ADDENDUM II

SUBJECT: Barbara Drive Drainage Phase 3 LF (2022 Bond), (WBS: 23-03927), Scheduled to Close: September 4, 2026; Date of Issue: July 31, 2026

THIS NOTICE SHALL SERVE AS ADDENDUM NO. II – TO THE ABOVE REFERENCED INVITATION FOR BID

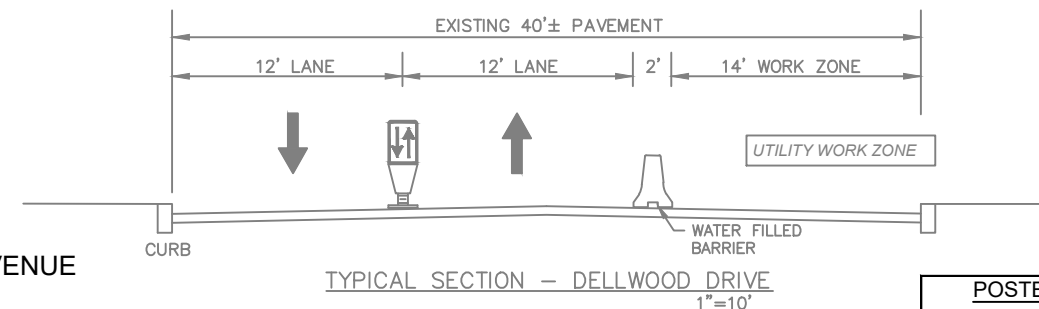
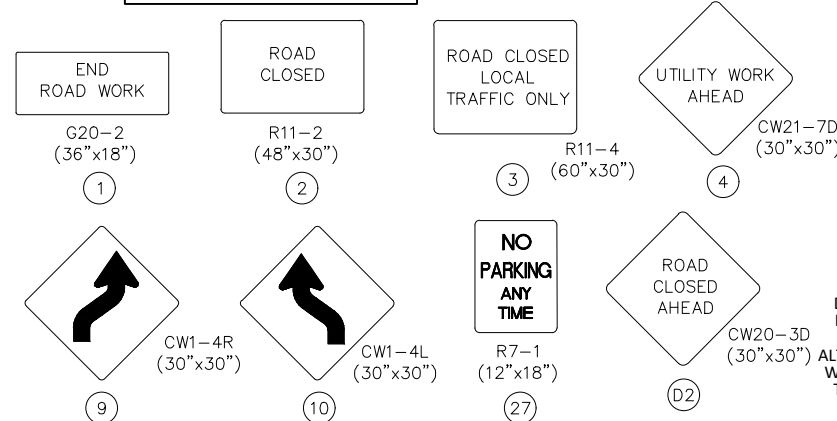
- Response: The order of the items has been corrected.
- Question 4: Where are the water barriers paid under?
- Response: Pay Item TXDOT 7114-7001 WATER FILLED BARRIER, has been added to the bid table. A specification for TXDOT 7114 WATER FILLED BARRIER has been added to the Project Manual

TXDOT ITEM	DESCRIPTION	UNIT	QTY
7114-7001	WATER FILLED TRAFFIC BARRIER	LF	298

100% SUBMITTAL	PROJECT NO.: 23-03927		DATE: 6-12-2026
DRWN. BY: MC	DSGN. BY: MH	CHKD. BY: KW	SHEET NO: 74 OF 183

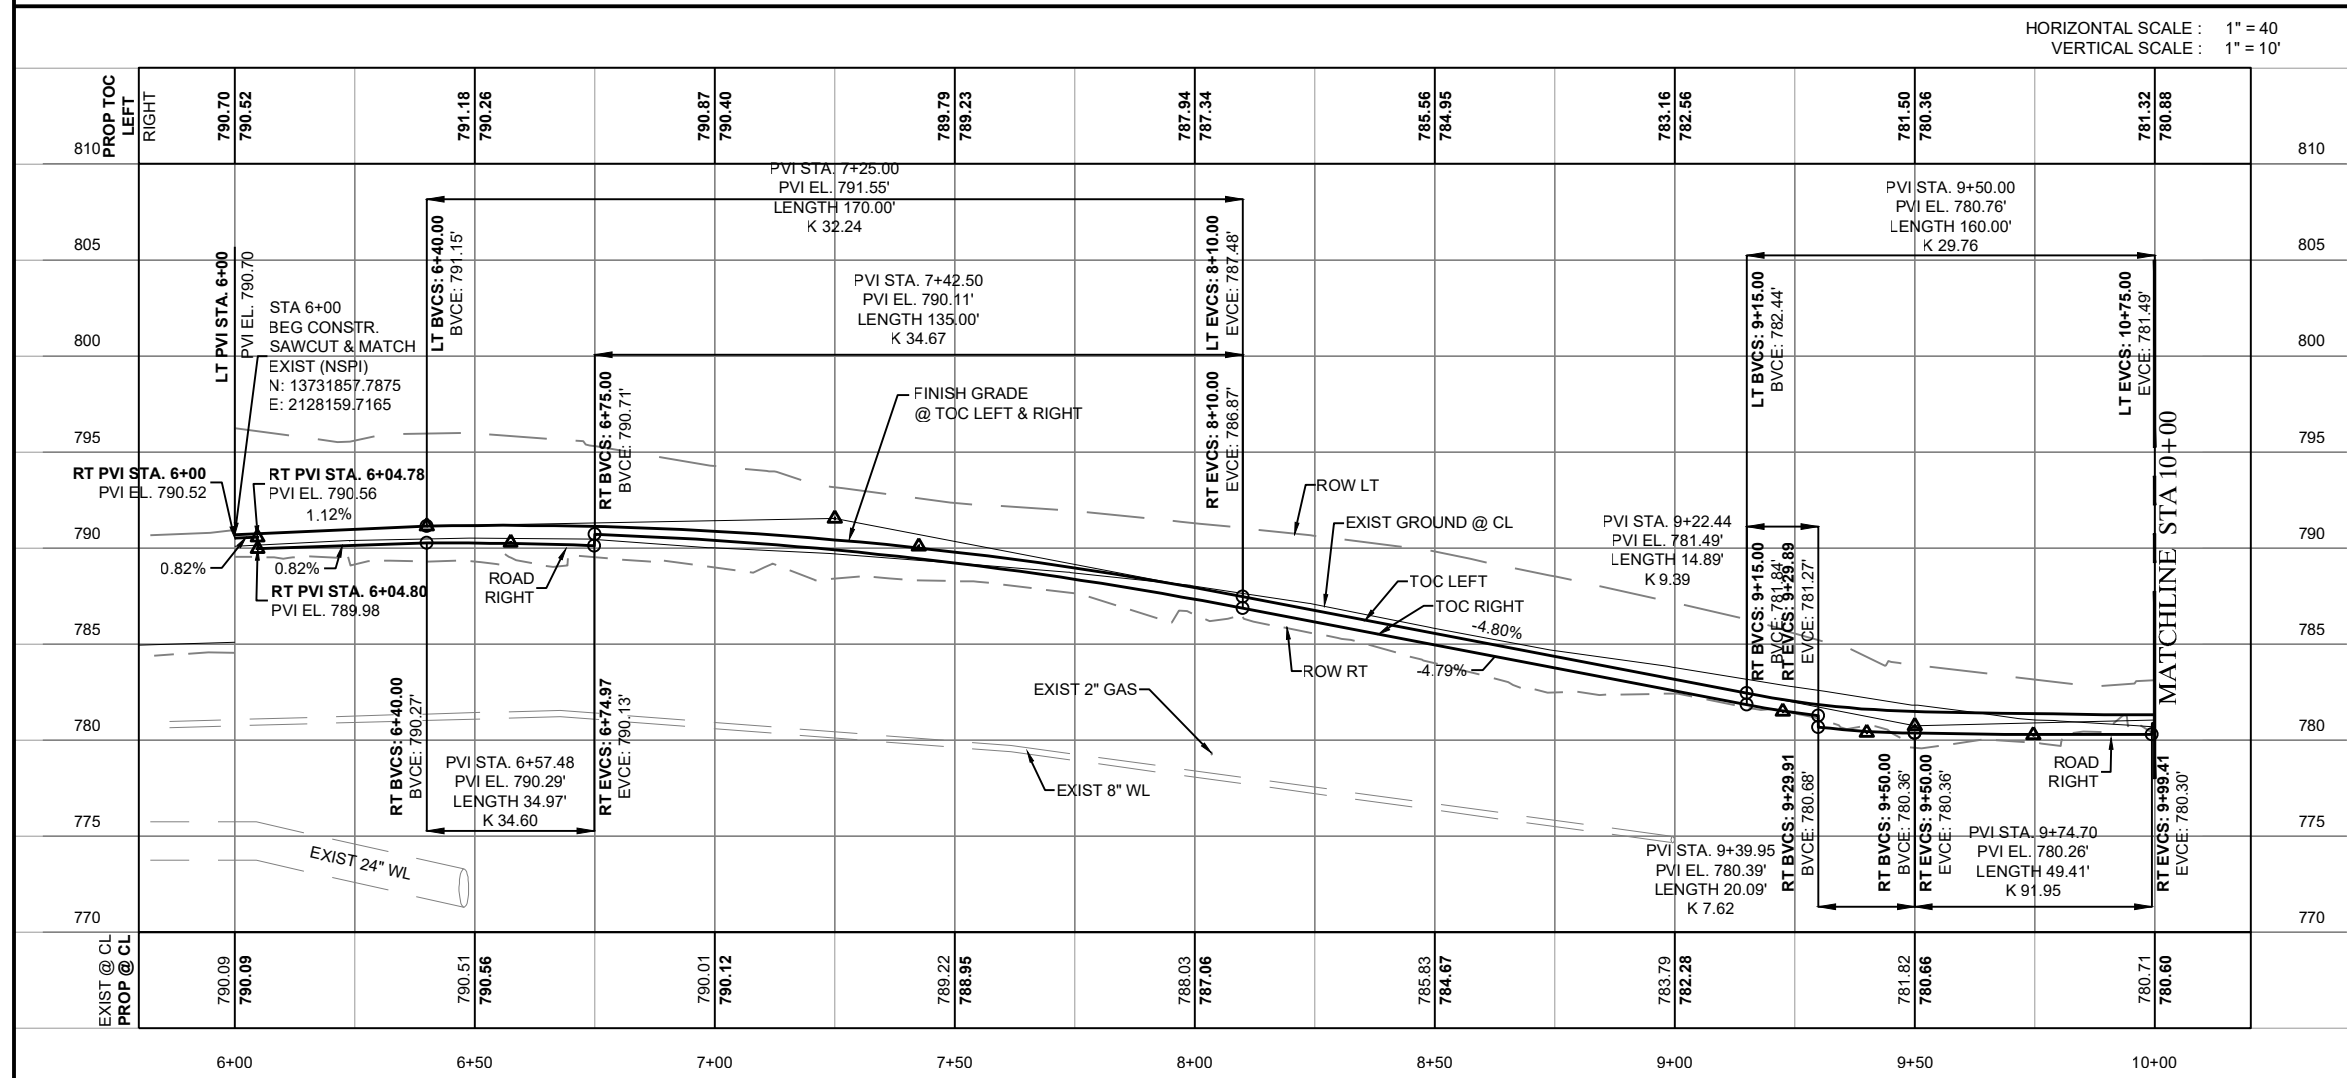
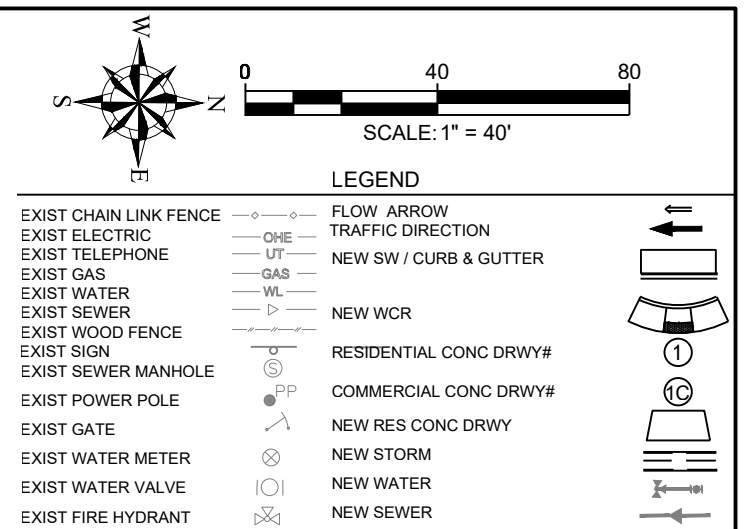
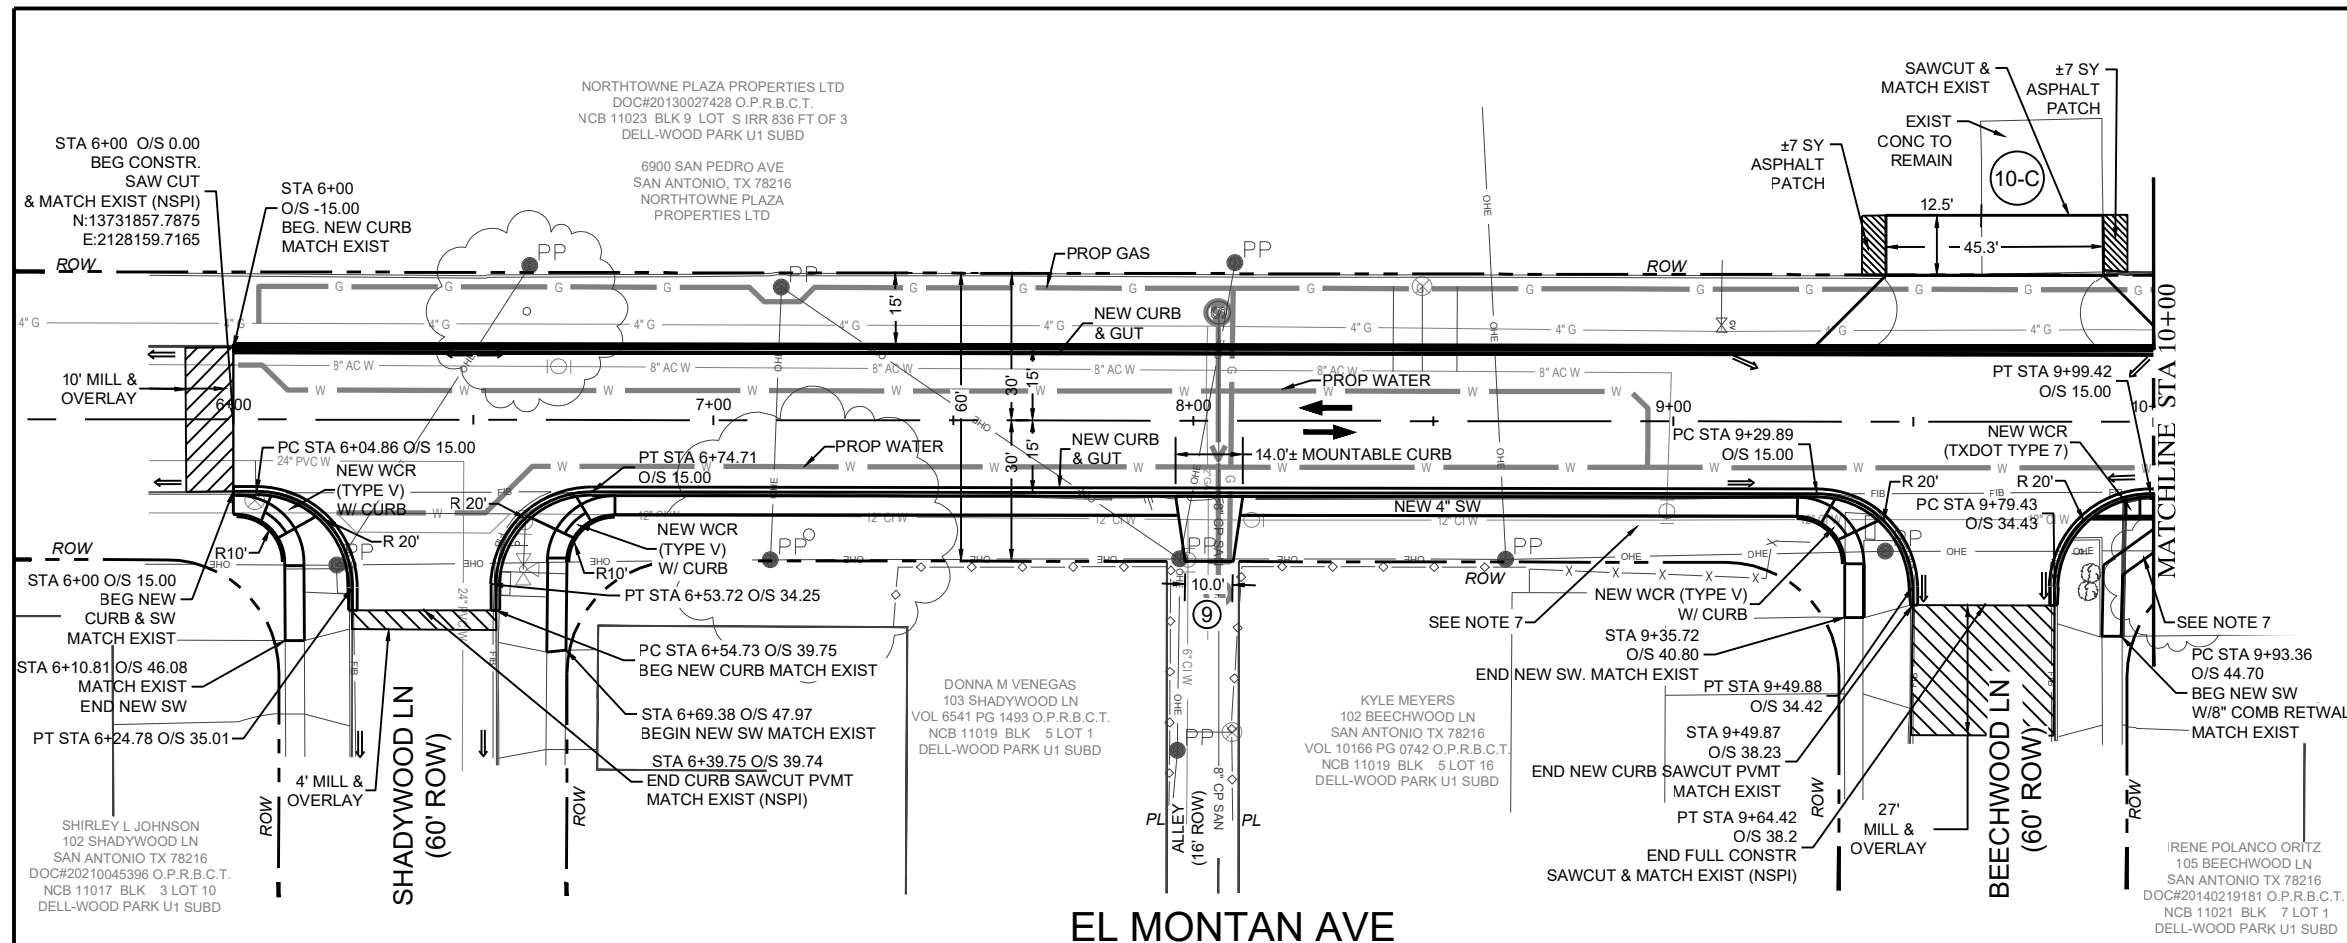
- Question 7: Mountable curb is called out on sheets 72, 74, 76, 77, 78, and 79 but are not included in the bid tab. Most are called out at the alleys while some are in front of driveways. Can the plans be adjusted to properly indicated where mountable curb will be required? Will the bid tab be revised to reflect mountable curb?

- Response: The plans indicated the curb lengths centered on the driveways at alleys and driveways. The mountable curb is to be paid under Item 500.5 Mountable Curb. A Special Provision to specification 500 has been added the Project Manual to address the pay item. The plans have been updated. Revised sheets 72,74,76,77,78,79 are attached

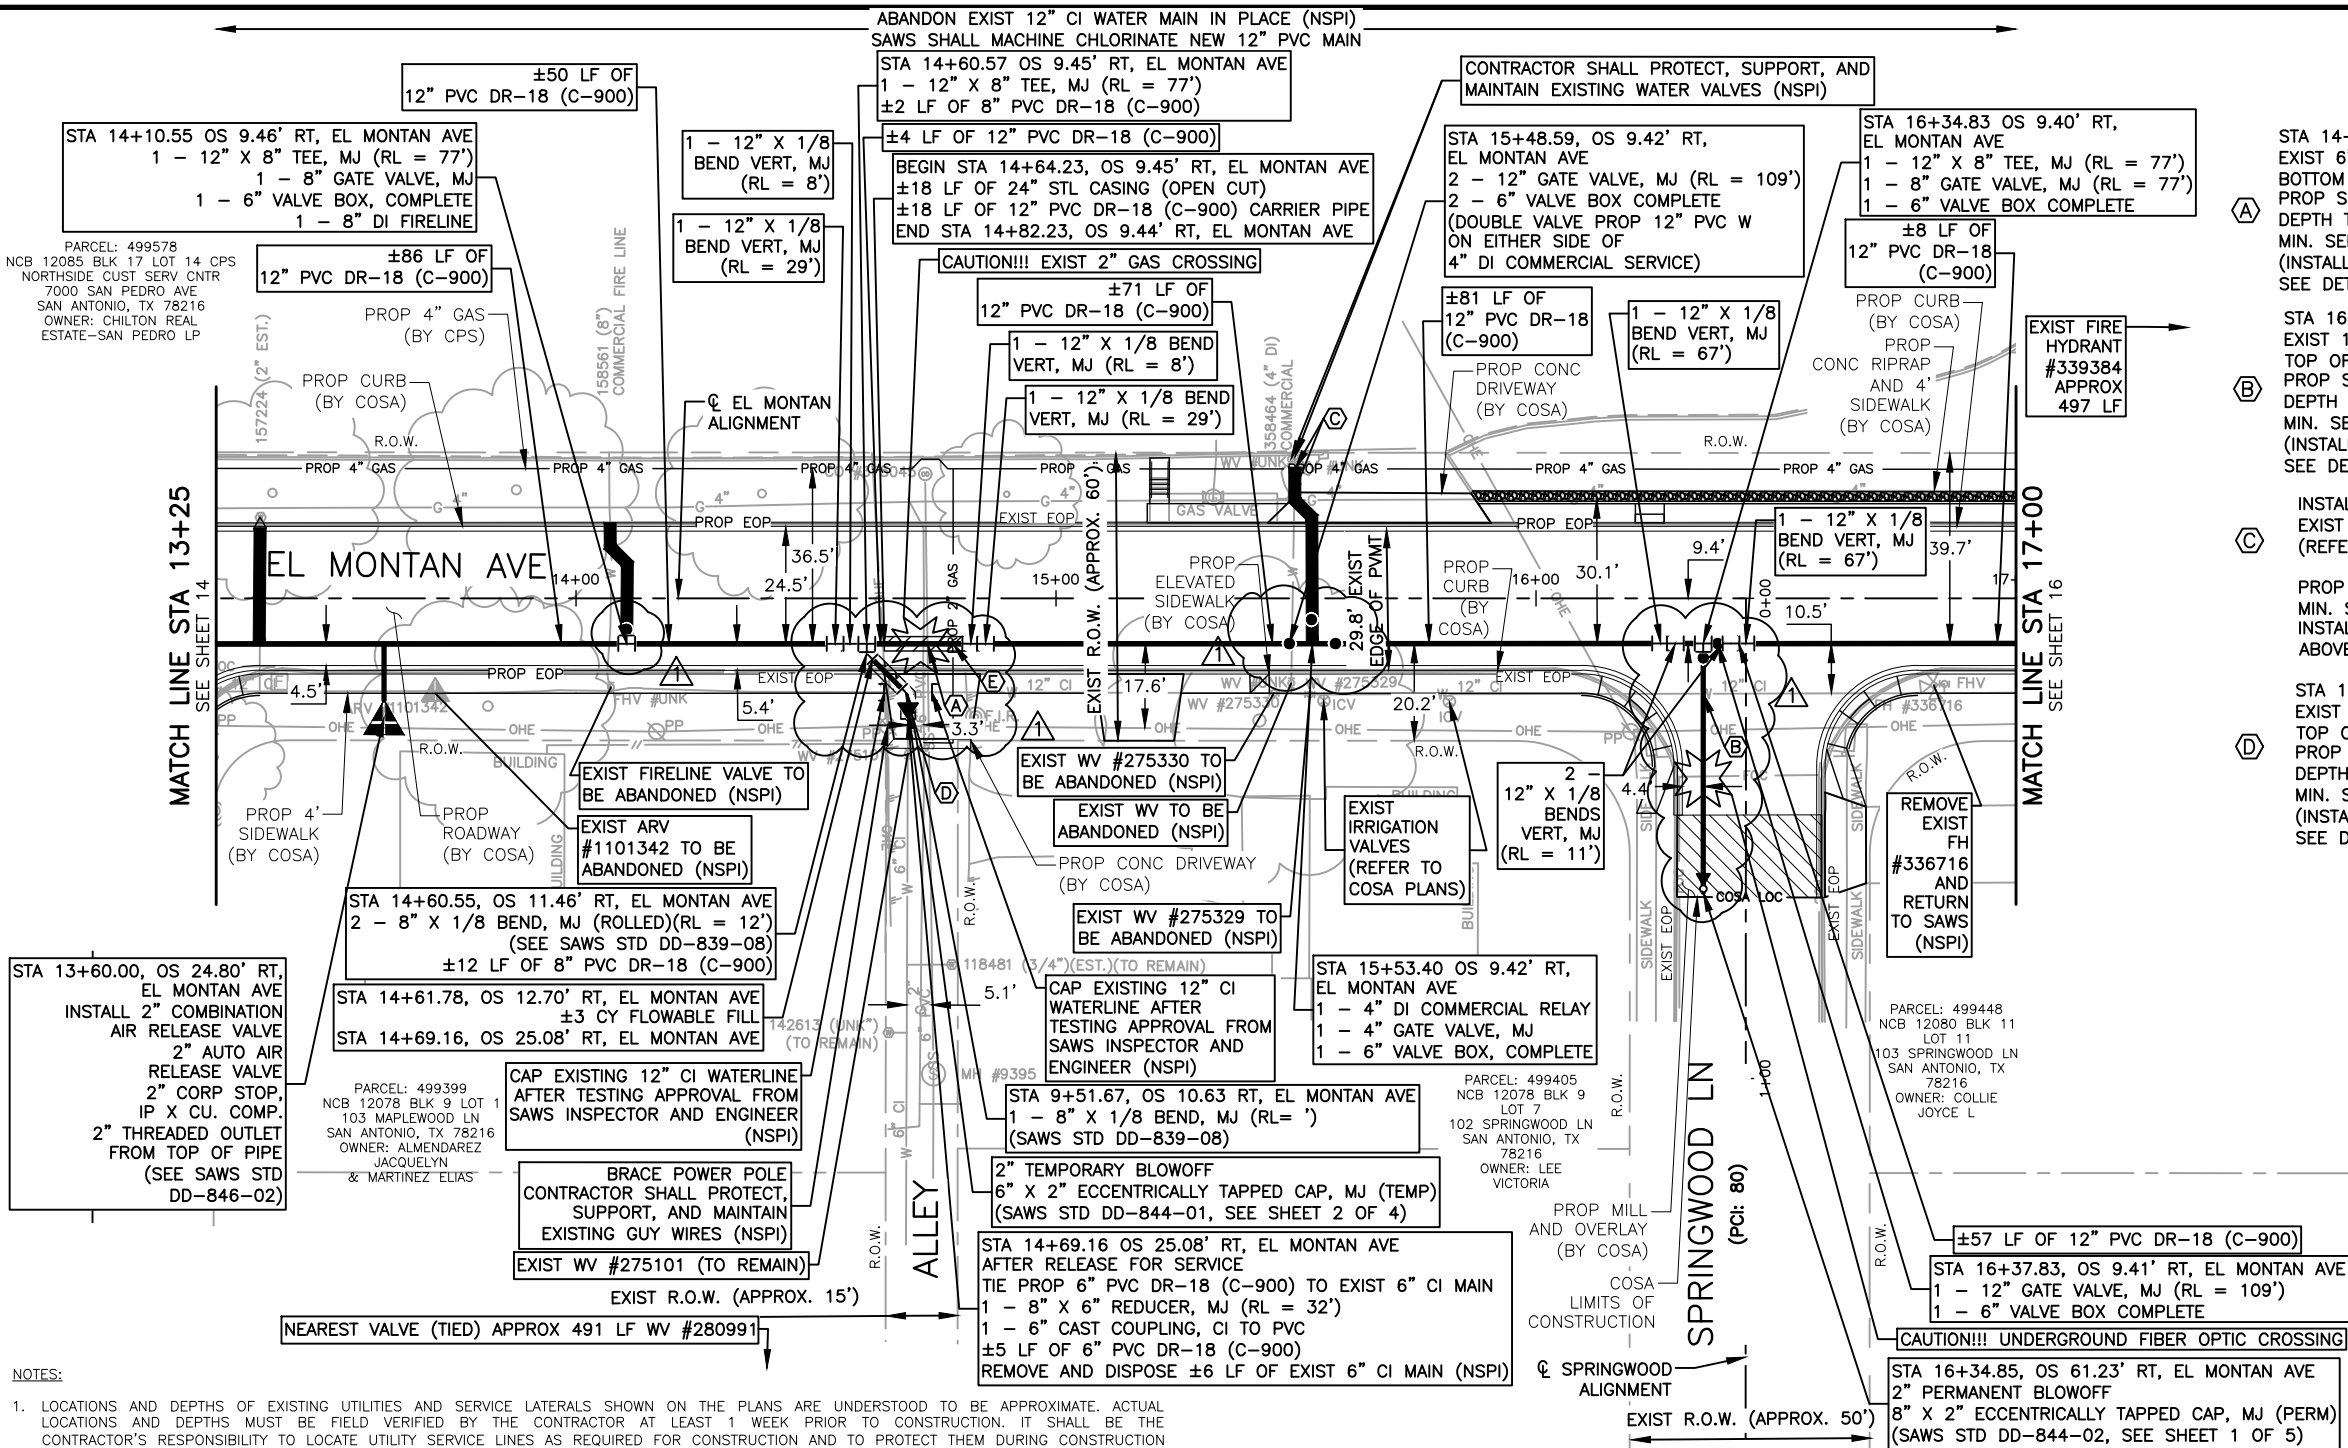
- Question 31: The callouts for the 8" PVC Waterline on sheets 13,14,15,16 are not very clear. Can you please provide a better detail of what you want here?

- Response: See the revised water sheets 13, 14, 15, and 16 that include the drawn 8" PVC Waterlines for clarity.
- Question 32: The fire hydrants on sheets 13,14, and 16 of the SAWS Water plans are not called out in the plans. Please advise.
